SOLICITATION AMENDMENT MODIFICATION DE L'INVITATION

Title - Sujet Transmission Main and Pumphouse Upg	
Solicitation No. - N° de l'invitation ED001-151187/A	Amendment No. - N° modif. 003
Client Reference No. - N° de référence du client 20151187	Date 2014-11-13
GETS Reference No. - N° de référence de SEAG PW-\$PWC-010-3491	
File No. - N° de dossier PWC-4-37088 (010)	CCC No./N° CCC - FMS No./N° VME
Solicitation Closes - L'invitation prend fin at - à 02:00 PM on - le 2014-11-18	Time Zone Fuseau horaire Atlantic Standard Time AST
F.O.B. - F.A.B. Plant-Usine: <input type="checkbox"/> Destination: <input checked="" type="checkbox"/> Other-Autre: <input type="checkbox"/>	
Address Enquiries to: - Adresser toutes questions à: MacDonald, Anne (PWC) D.	Buyer Id - Id de l'acheteur pwc010
Telephone No. - N° de téléphone (902) 626-4949 ()	FAX No. - N° de FAX (902) 566-7514
Destination - of Goods, Services, and Construction: Destination - des biens, services et construction:

The following changes in the tender documents are effective immediately. This addendum will form part of the contract documents.

1. On Drawing C1, Civil Plan & Profile, Stations 0+000 to 0+070

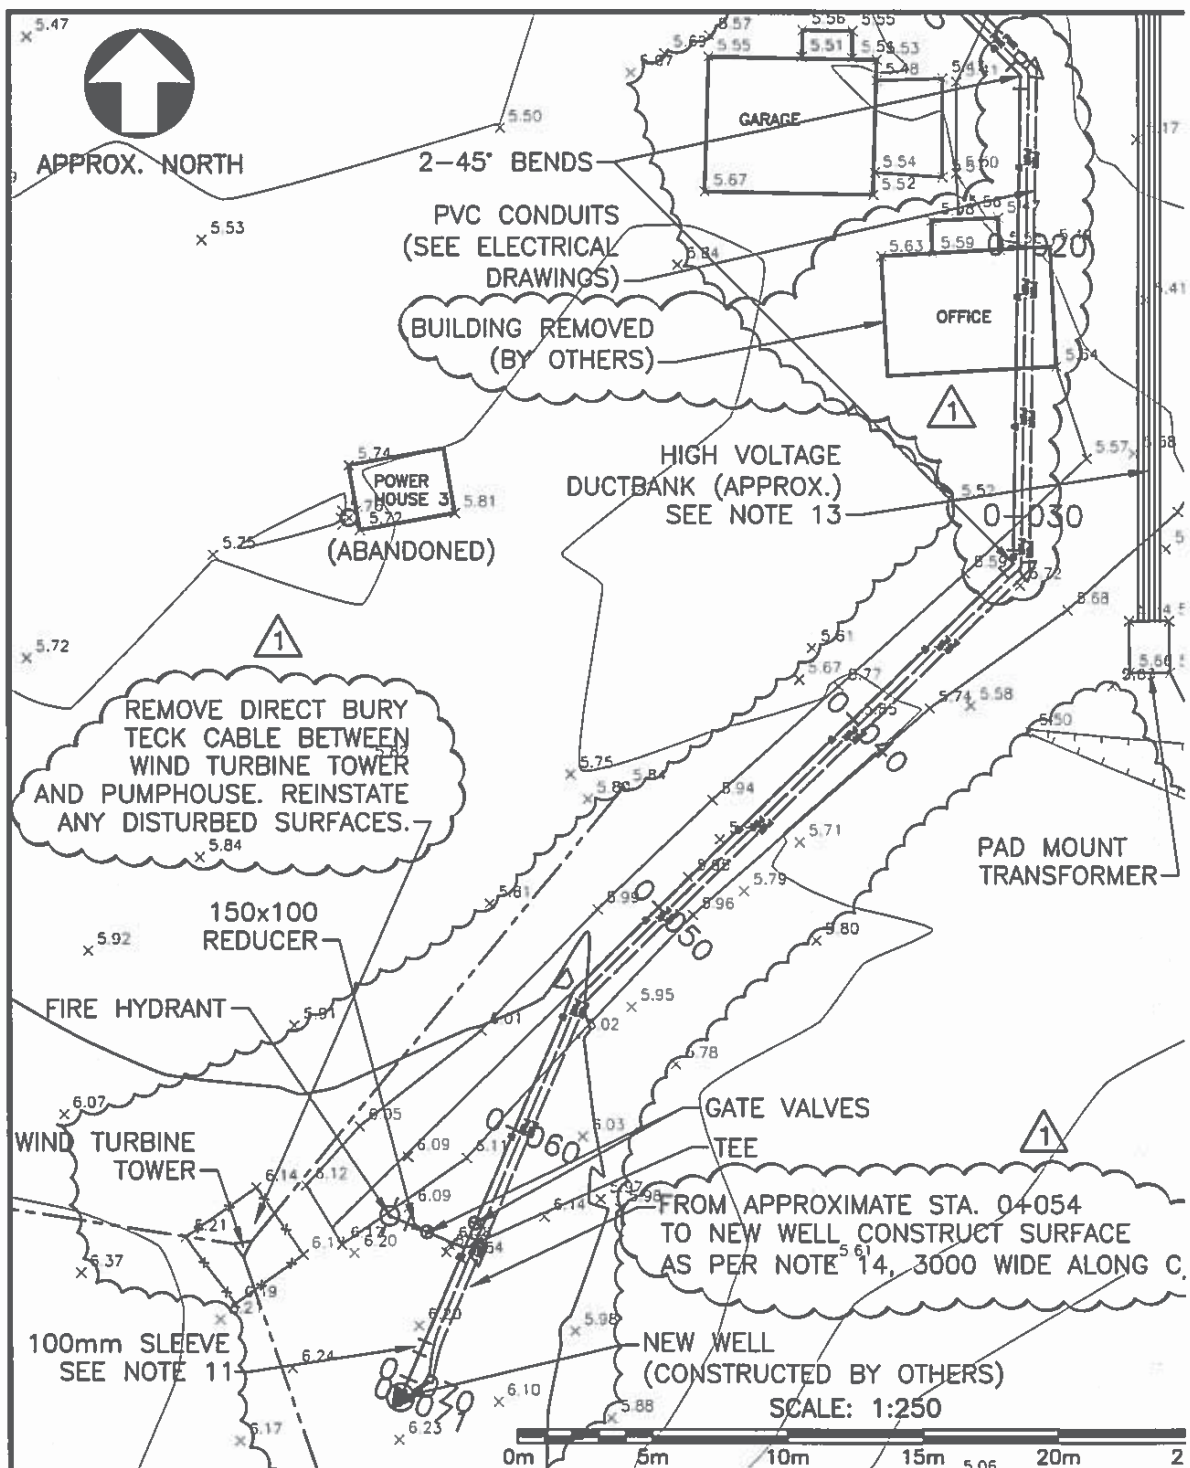
- .1 Revise the plan location of the proposed watermain and the electrical conduits as per the attached Addendum Sketch SK1.
- .2 Profile, add the following note: "Install watermain with a uniform slope up from the existing well's pitless adapter stub elevation to approximate elevation 4.05 at the pump house."
- .3 Add the following note: "Remove direct bury Teck cable between wind turbine tower and pumphouse. Reinstate any disturbed surfaces."
- .4 Add the following note: "From approximate Sta. 0+054 to new well construct surface as per note 14, 3000 wide along C/L."
